Access Compliance Report Public Rights-of-Way (RR Crossings)

Intersection ID: 18726	Main Street: TYVOLA_RD	Location: N/A
ADA ID: 6F466530130F	Overall Compliance: No	Severity Score: 0.0
Codes/Mitigation Info/Possible Solution		Field Measurements/Component Compliance

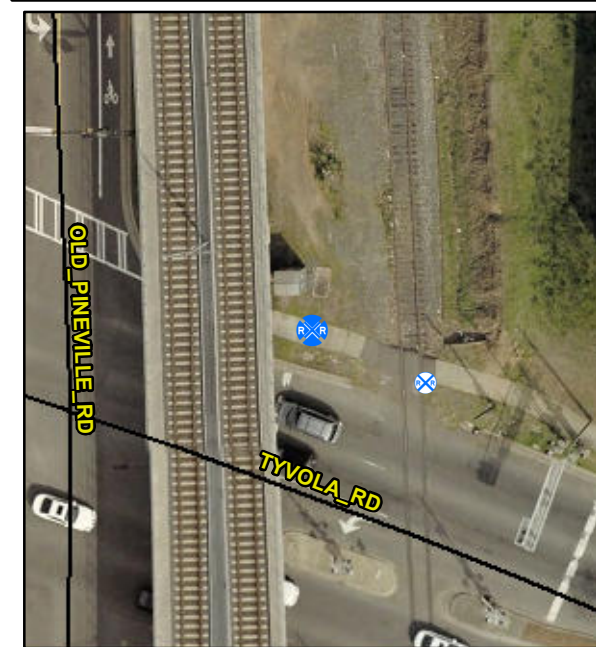
**Install Detectable Warning System.
Provide Pedestrian Gate. Remove &
Replace Walking Surface Adjacent
to Rail.**

Compliance	Description	Data
No	DWS Provided?	No
N/A	DWS Contrast?	N/A
N/A	DWS Width (in)	N/A
N/A	DWS Length (in)	N/A
N/A	DWS Offset (in)	N/A
No	Pedestrian Gate?	No
N/A	DWS Outside Gate?	N/A
N/A	Rail Type?	Freight
No	Flangeway Gap (in)	3.0
Yes	Sidewalk Width (in)	72.0
